Waipā District Plan Plan Change Submission Form

Plan Change Number and Name: Plan Change 13 - Uplifting Deferred Zones

3796 Cambridge Road/Proposed C4 Growth Cell Traffic Comments

Figure 1: Existing C4 Plan

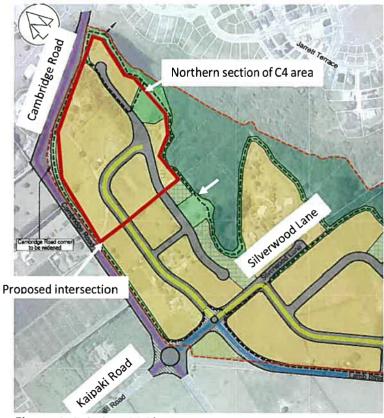
Whilst we support in principal the uplifting of the deferred zoning we wish to see an alteration to the C4 Structure Plan. Specifically we would like to see a second entrance provided off Cambridge Road. Currently the C4 Structure Plan provides a single entrance via Silverwood Lane. The reasons for a second entrance are as follows:

Whilst the C4 Structure Plan has been endorsed by Council to our knowledge this has not been tested through a hearing process and Council have not provided an evidential basis for their rejection of the suggestion of a second entrance, which was made by Mr Maunsell in response to the feedback sought on the draft structure plan. It is noted the Transportation Assessment prepared by Gray Matter provided comments in respect to an additional access to the north. These comments have been addressed in Ms Hills report.

7. I seek the following decision/s from Council: (give precise details – e.g. what you would like the wording of a specific provision (or map) to be changed to)
An alteration to the C4 Structure Plan providing an additional access from Cambridge Road to the northern portion of the C4 growth cell.

Figure 4: Land serviced by new intersection

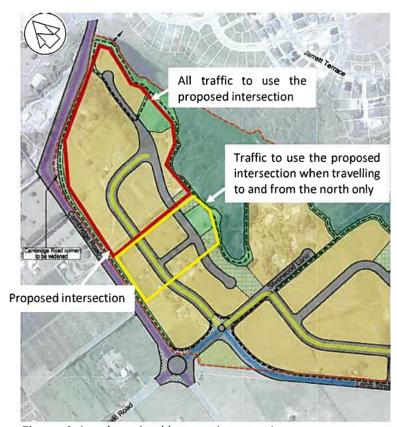
All site traffic to the north of the intersection and just to the south of it, is expected to use the proposed intersection for all movements. Traffic generated by land to the south of the proposed intersection is expected to use the proposed intersection to travel to and from the north, and to use the Kaipaki intersection to travel to and from the south, as indicated in Figure 4. This is a relatively coarse model, but is considered to be sufficient for this initial assessment.

Figure 8: Potential road hierarchy

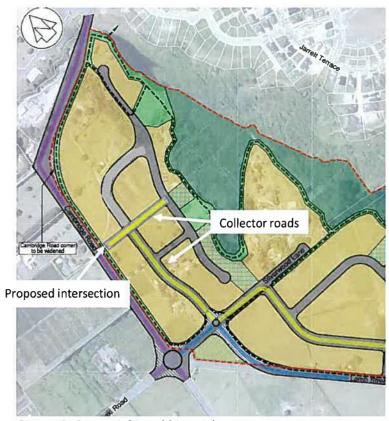
The current C4 layout includes a north/south collector road from Silverwood Lane north. The collector road designation may not be necessary with the proposed site design. Alternatively, the road in from the proposed intersection and a connection between this road through to Silverwood Lane may be designated as collector road. This road hierarchy is indicated on Figure 8. The final site layout will also need to tie in with the proposed layout to the south of the site.

Figure 13: Access separation distances

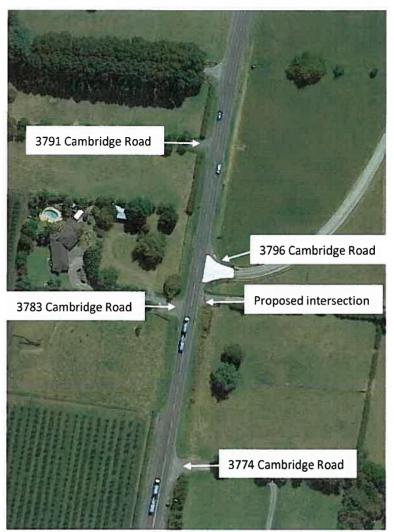
The intersection separation distances at the proposed intersection are acceptable, however the access to intersection distance does not meet the required criteria.

The 80 km/h posted speed requires a 100 m access to intersection separation distance. Accesses within this distance include the following:

- 3783 Cambridge Road directly opposite the proposed intersection.
- 3796 Cambridge Road 15 m north of the proposed intersection, on the same side of the road.
- 3791 Cambridge Road 85 m north of the proposed intersection, on the opposite side of the road.
- 3774 Cambridge Road 95 m south of the proposed intersection, on the same side of the road.

As part of the site development the existing 3796 Cambridge Road access will be closed. It is also anticipated that 3774 Cambridge Road will be closed when the adjacent land is developed. The access at 3791 Cambridge Road is considered to represent a relatively minor shortfall in separation distance (100 m required and 85 m provided). It is also noted that if the speed limit drops to 60 km/h following development of the C4 area, then the required separation distance will only be 30 m. This leaves 3783 Cambridge Road as the adjacent access of most concern. While staggering intersections is good design practice, for accesses a better design where separation distance cannot be met is to locate them directly opposite adjacent accesses/intersections. This design reduces the number of conflict points along a road and the potential for blocked sight distances from vehicles waiting to turn right off the main road.

Figure 14: Austroads AGTM Part 6 (2020) Figure 3.25 – turning warrants

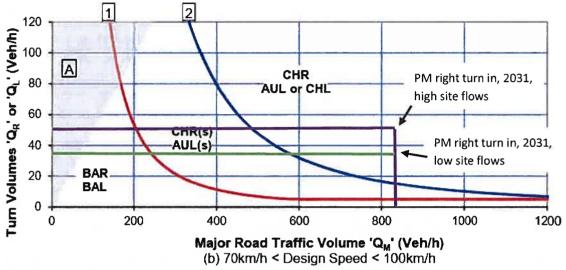
Austroads Guide to Traffic Management Part 6 (2020) Figure 3.25 (provided in Figure 14 of this letter) indicates that a right turn bay will be required at this site over the likely range of development densities. The threshold where a right turn bay is not required is approximately five right turn in vehicles in the peak hour – approximately 21 dwellings (21 x 0.8 in x 0.36 from the south /1.2 trips/dwelling).

Figure 15: Tanner graph (1962) for right turn out movement

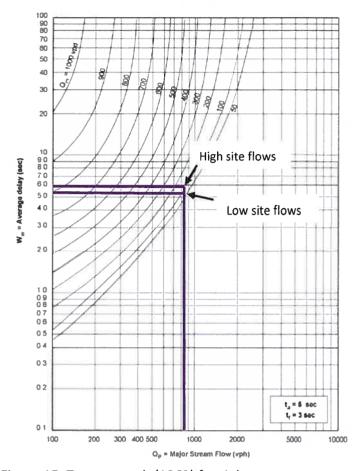
An initial check of intersection capacity has been made using Tanner's graph for the right turn out movement (Figure 15). This graph indicates that average delay for right turn out vehicles will be between five to six seconds for the 2031 AM development scenarios. This delay is considered to be acceptable, and unlikely to result in any capacity issues in the medium-term horizon.

Delays are expected to become unacceptable when the peak hour traffic volume on Cambridge Road exceeds approximately 2000 vph, giving average delays of greater than 40 seconds. At current growth rates this traffic volume would take over 37 years to achieve. When delays become unacceptable the proposed intersection would either need to prevent right turn out movements or be converted to a roundabout. Preventing right turn out movements could be achieved by installed a central median to the south of the intersection, requiring right turn out traffic to turn around at the proposed Kaipaki roundabout instead.
